# **STANDARDS AND POLICIES MANUAL**

## **VOLUME I**

Technical Bulletin One

**NOVEMBER 2012**

**SD  
4A**

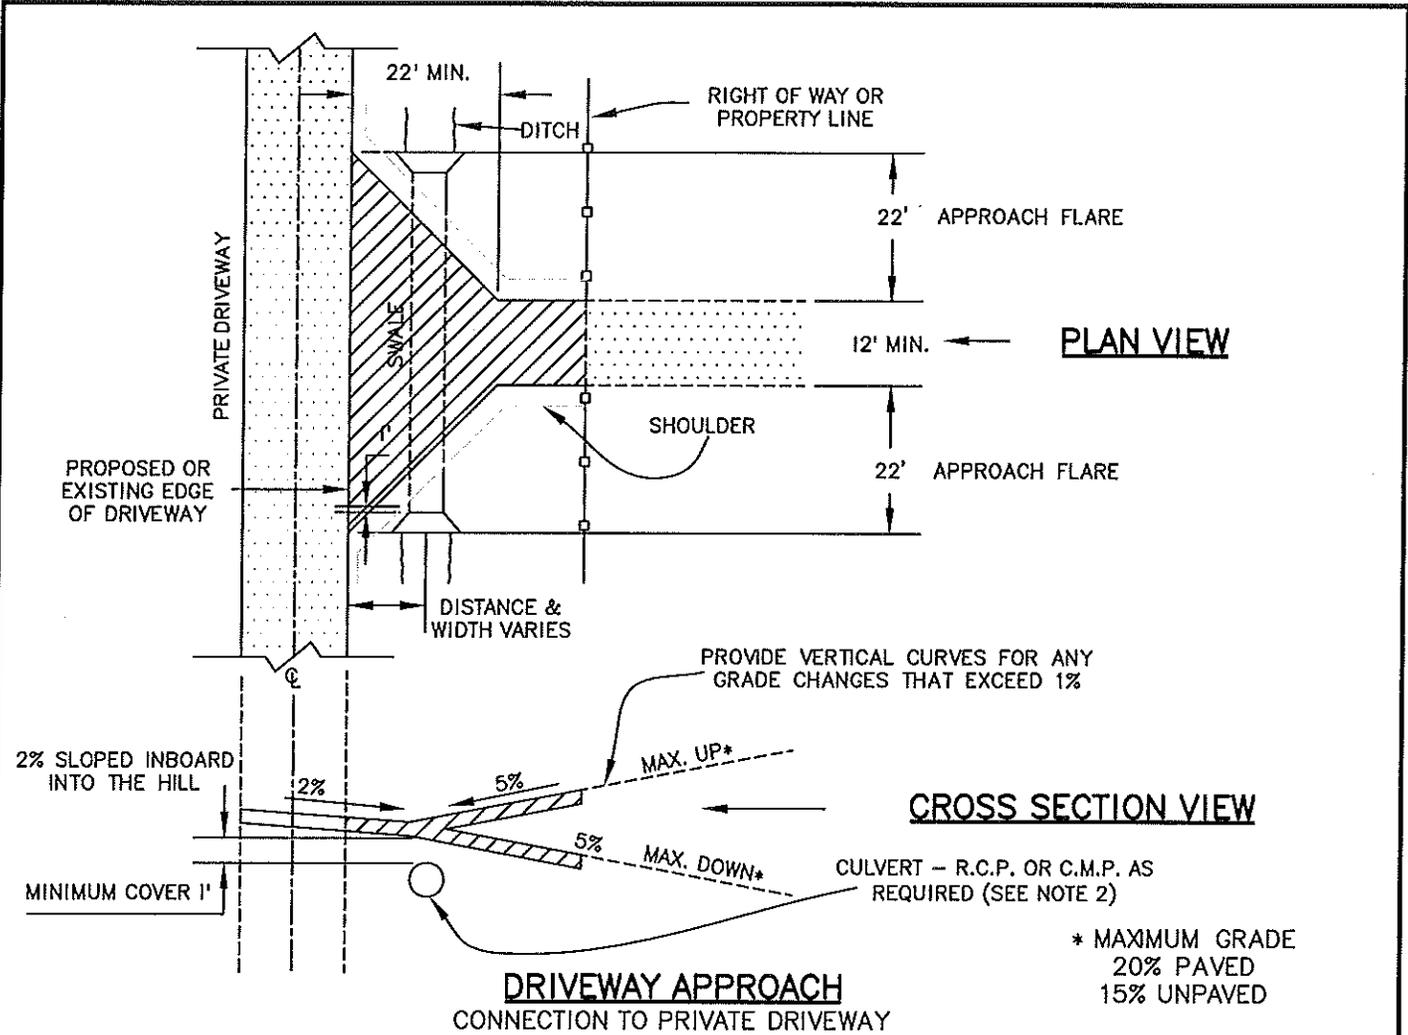
DRIVEWAY APPROACHES: The SD4 driveway approach detail in the Manual is only intended for use in connecting Driveways to Access Roads. The addition of Standard Detail SD4A makes it possible to connect a twelve-foot driveway to a second twelve-foot driveway, with an expanded driveway approach. The detail was developed and designed to include additional paved area, required by fire engines, and is therefore larger than the detail SD4, which will be continued to be utilized in driveway-to-access road connections.

The SD5 detail sheet is revised per the following attached details (Attachment 1) and replaces the existing detail of the current label, and an additional detail SD4A shall be added to the Manual.
